**LEGAL ADVERTISEMENT
HISTORIC PRESERVATION BOARD
CITY OF PORTLAND
Public comments will be taken at all meetings**

HISTORIC PRESERVATION BOARD AGENDA

This memo addresses the changes that have been made to the design of the addition at 722 Congress Street in response to comments received at the historic workshop on April 16th and our meeting with Rob Wiener and Deb Andrews on July 22nd.

722 congress street
04.09.2014

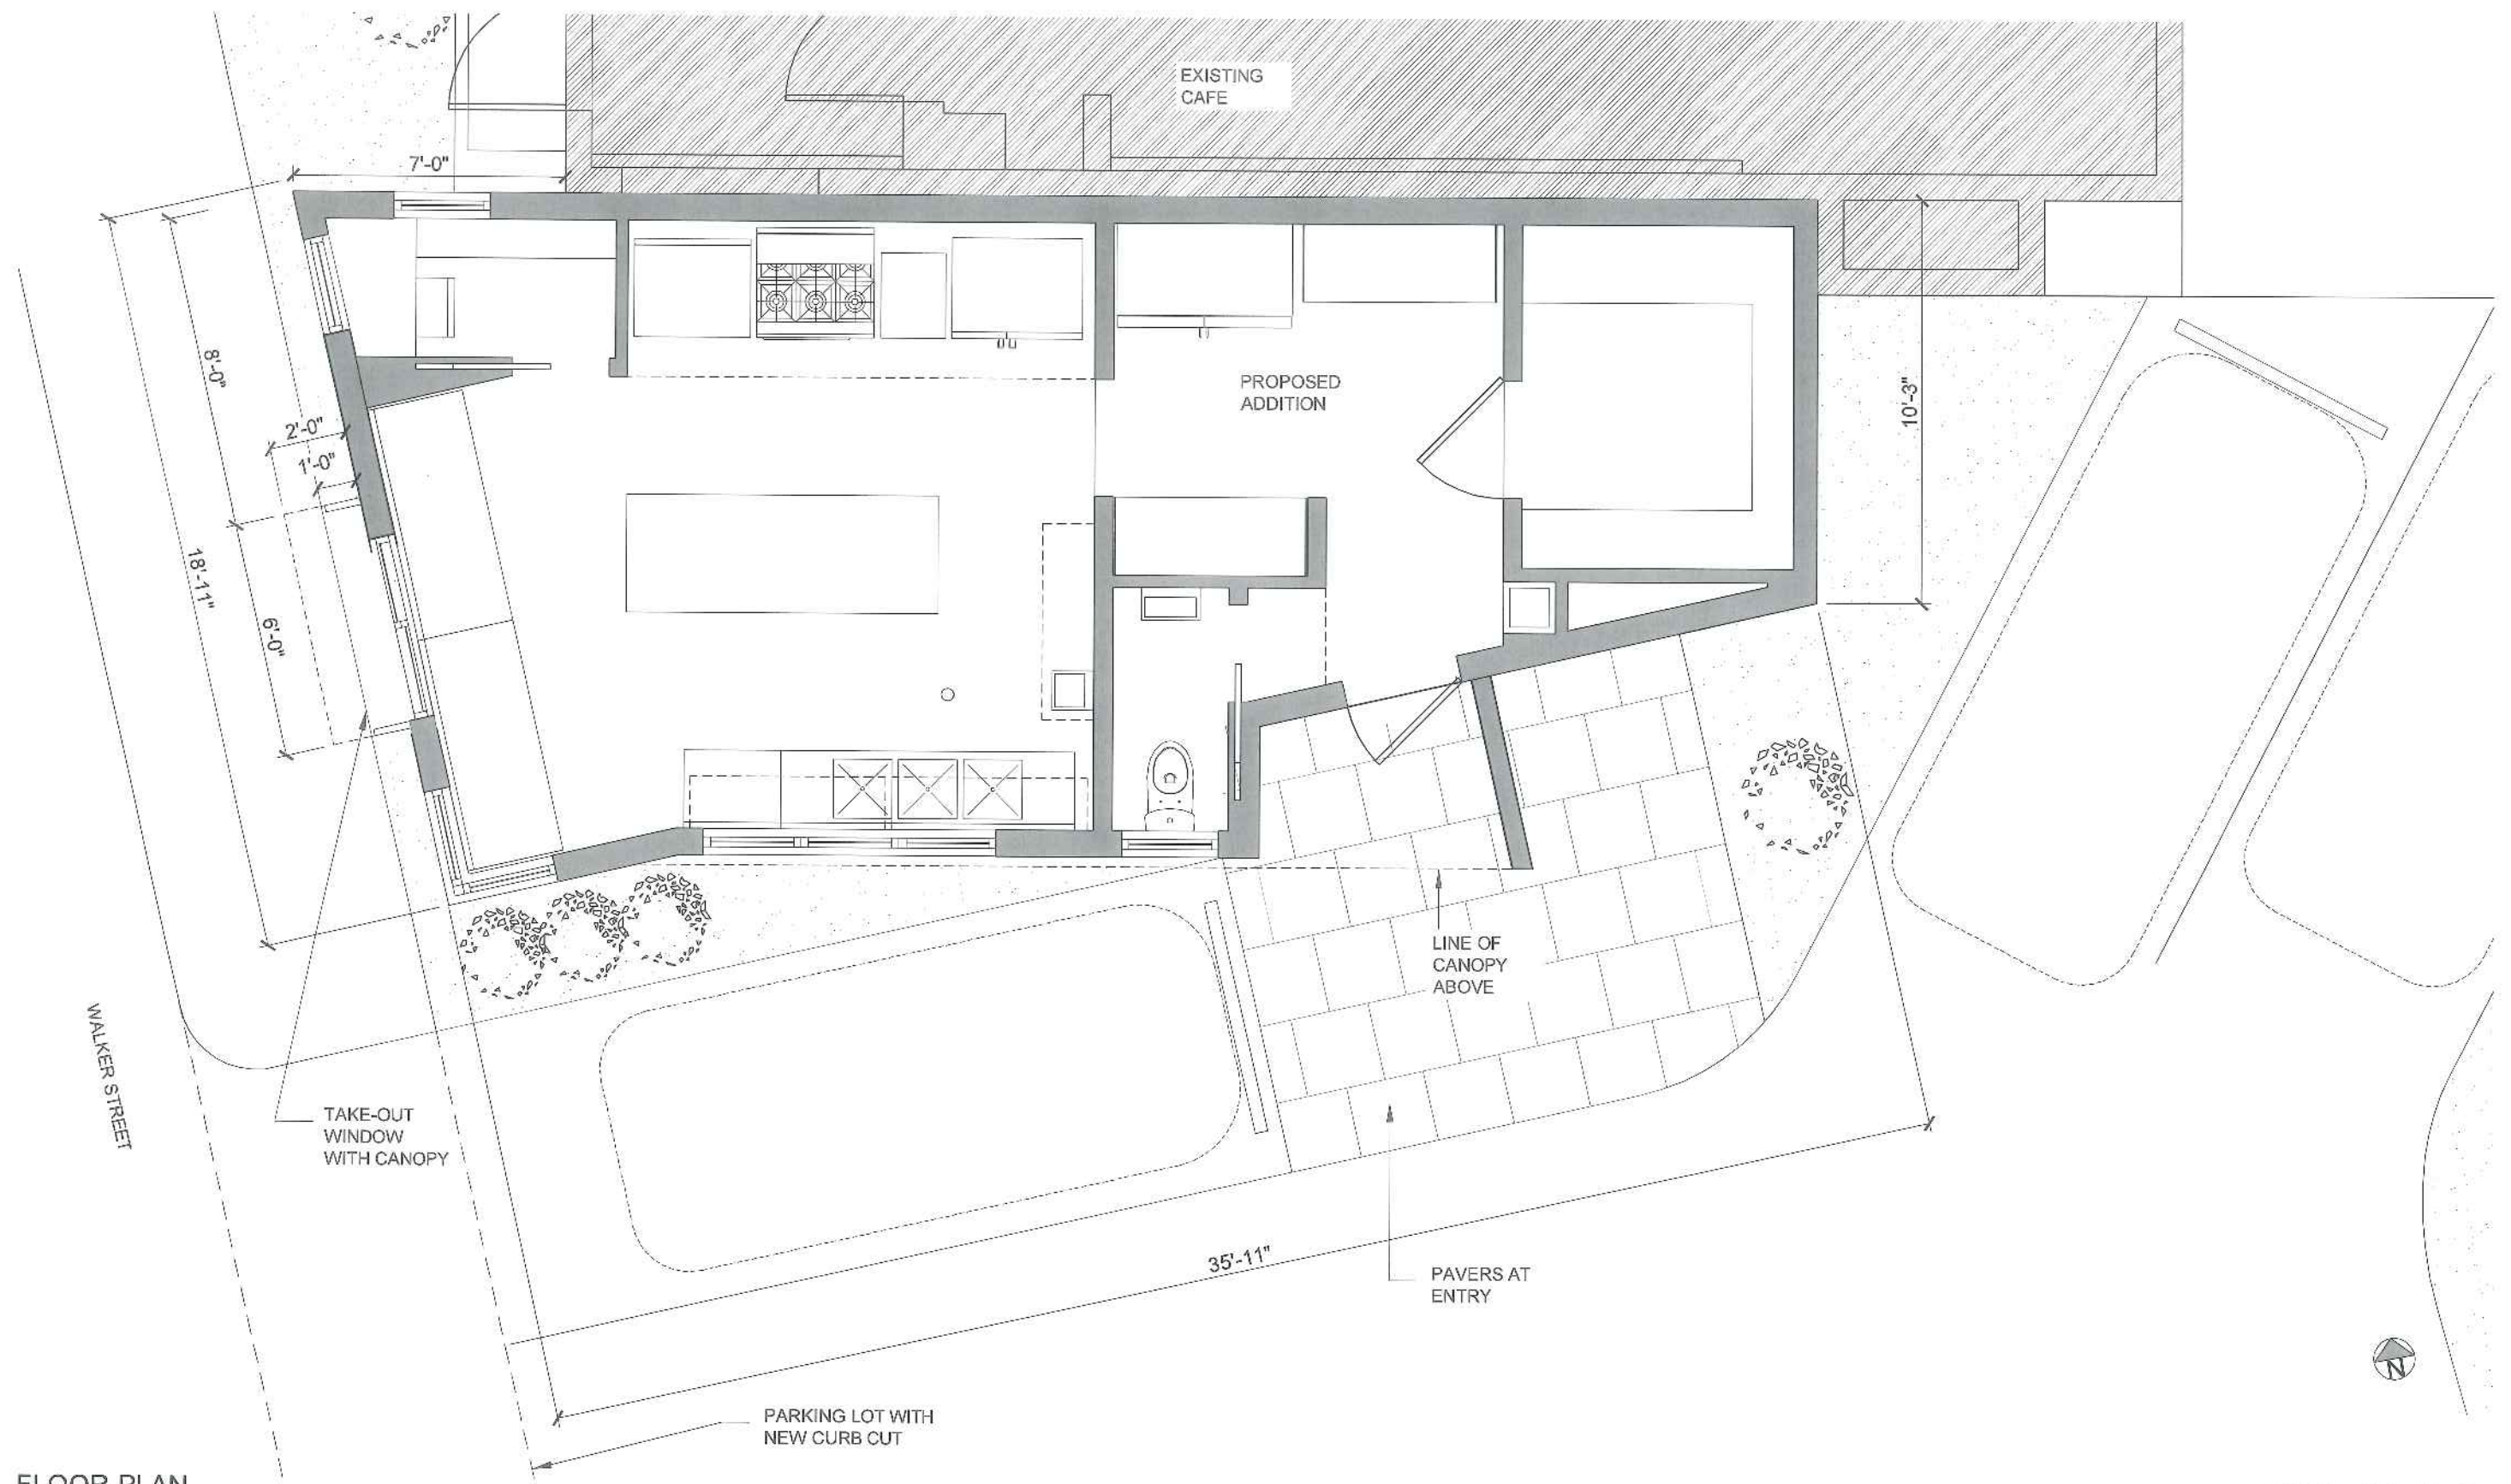
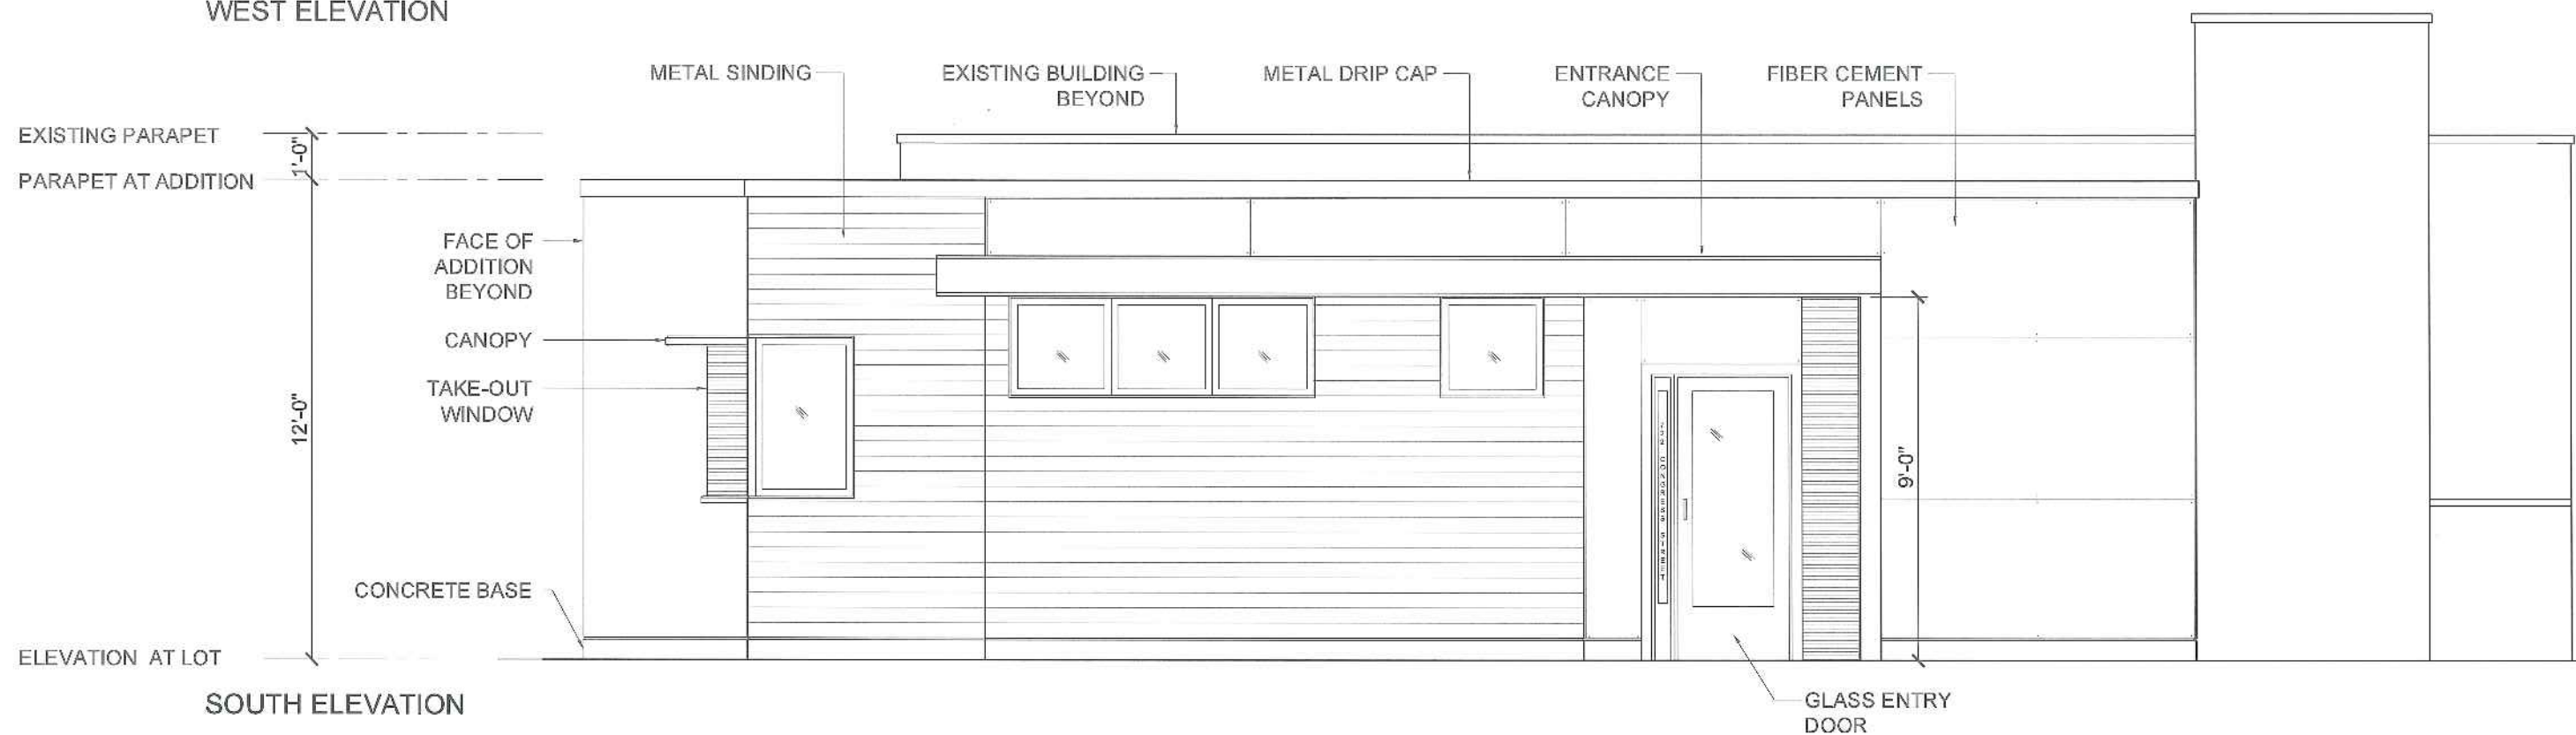
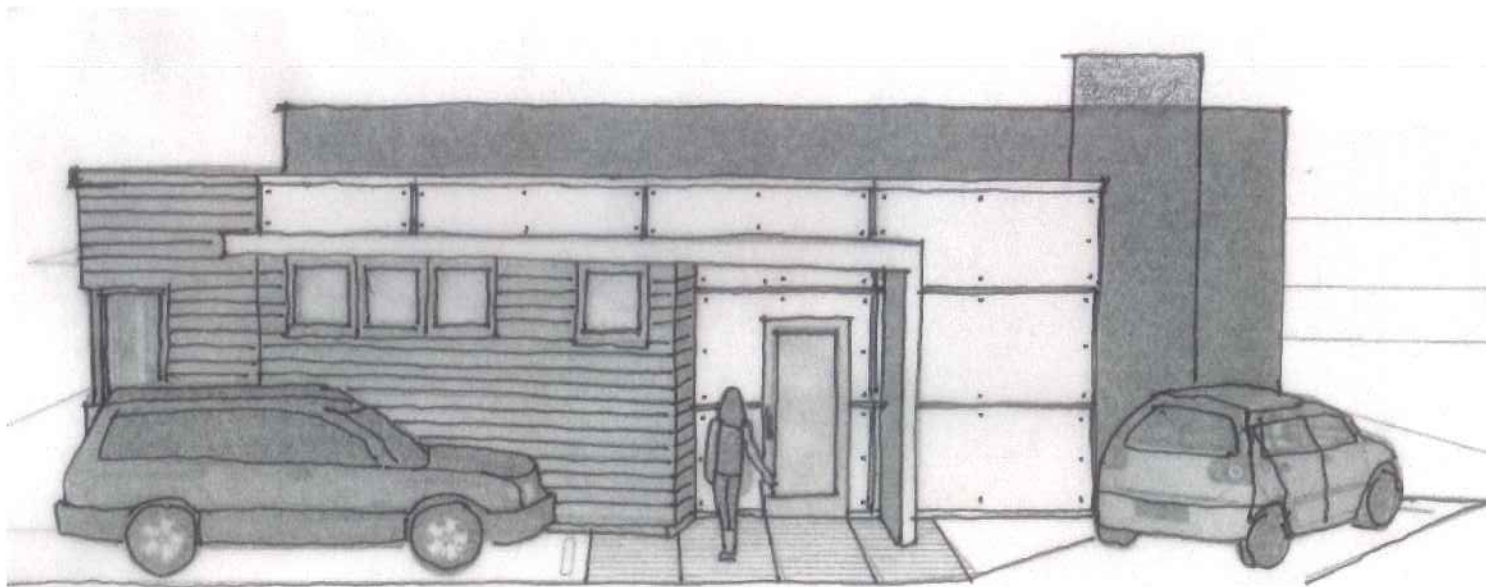
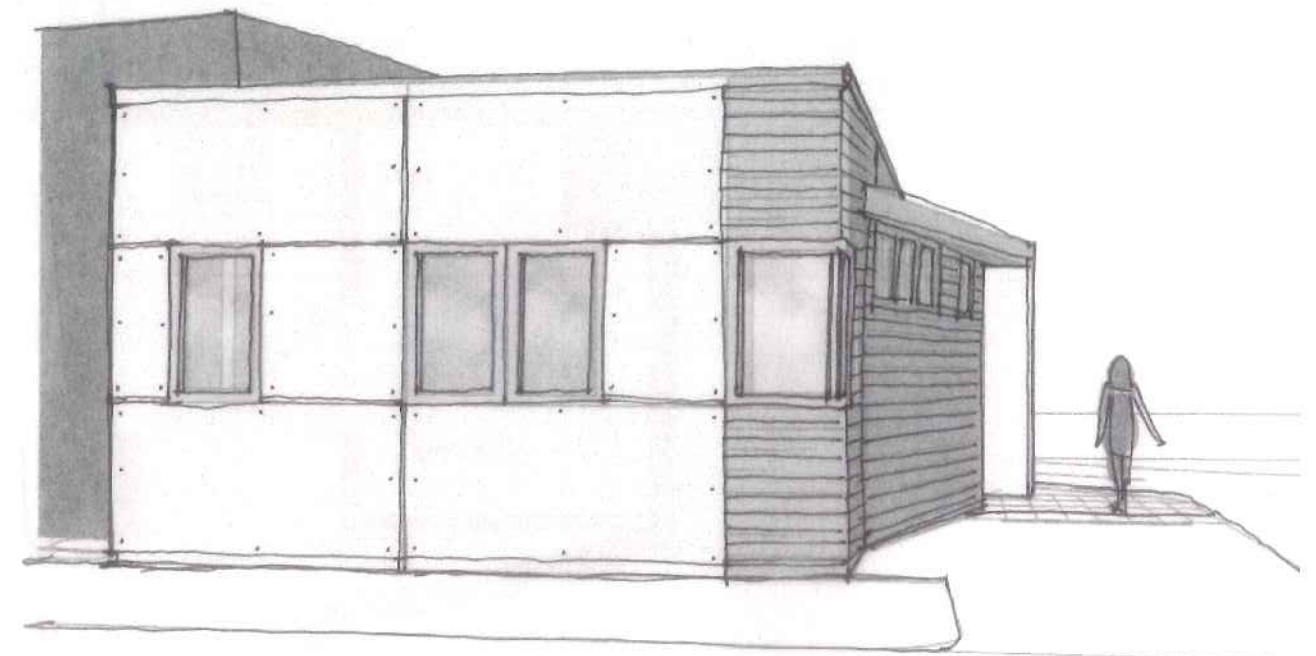
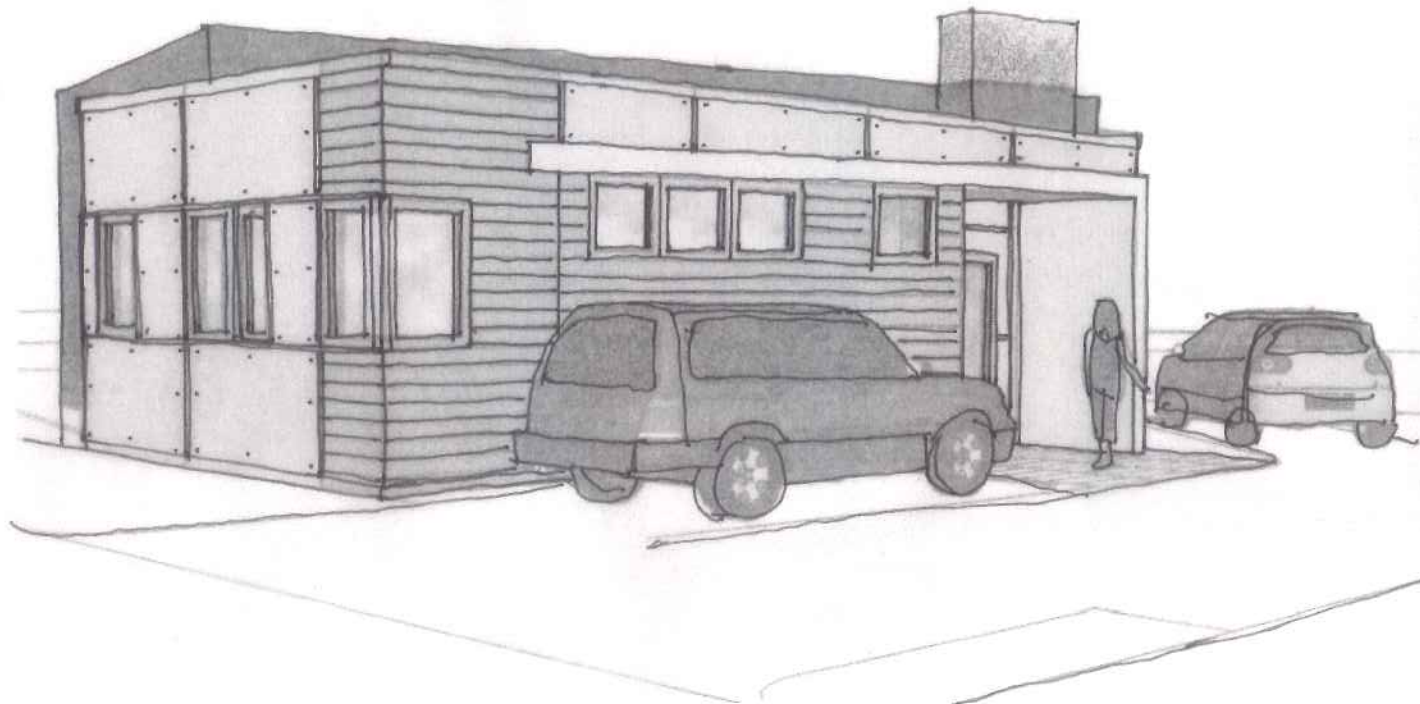
- The Board recommended that a master plan and timeframe for improvements to the existing building be developed in conjunction with the design process for the new addition. Without addressing the principal structure, Board members were concerned that the complex would read as oddly disjointed: an undistinguished renovated commercial block to which a smaller, thoughtfully designed rear addition had been attached. While the Board appreciated the fact that it might not be financially feasible to undertake improvements to the whole building at this time, thought should be given to an overall design concept that ensures the two building components are architecturally related.

- Related to the above concern, Board members noted that the proposed design solution for the small addition featured a wide variety of materials and treatments, including corrugated metal siding, fiber cement panels with exposed fasteners, natural wood slats, etc. Some members of the Board questioned whether the treatment of the addition might be toned down a bit, especially given its secondary position as a rear addition.

- Board members recommended pushing the Walker Street elevation of the addition back from the sidewalk and back from the rear corner of the existing building. This would succeed in aligning the face of the addition with the established setback of the residential development beyond and allow unencumbered views of the Peabody House at 4 Walker. By setting the facade back it would also ensure that the addition didn't unduly dominate the principal structure—especially since there were no immediate plans for improvements to the principal structure.

The main issues brought up by the board were the relationship between the addition and the existing commercial building that currently houses Yordprom Coffee Company, and the relationship to the surrounding residential West End neighborhood. More specifically, we discussed the material character of the addition, its adjacency to the Peabody House, which our client also owns and lives in, and the setback from Walker Street.

Our intent is to create a building that is respectful of its surroundings and unique site, which improves upon the current parking lot and contributes to Portland's dynamic urban fabric. After listening to the feedback from the board we have incorporated the following changes:

- The landscaping will be upgraded. The existing planter on Walker Street will be rebuilt with new granite curbing to tie into the design of the outdoor seating area. There will also be new granite curbing and a lushly planted bed between 722 Congress and the Peabody House to distinguish between the parcels. The intent is to extend the character of the residential neighborhood around the perimeter of the Peabody House without obscuring it from view.
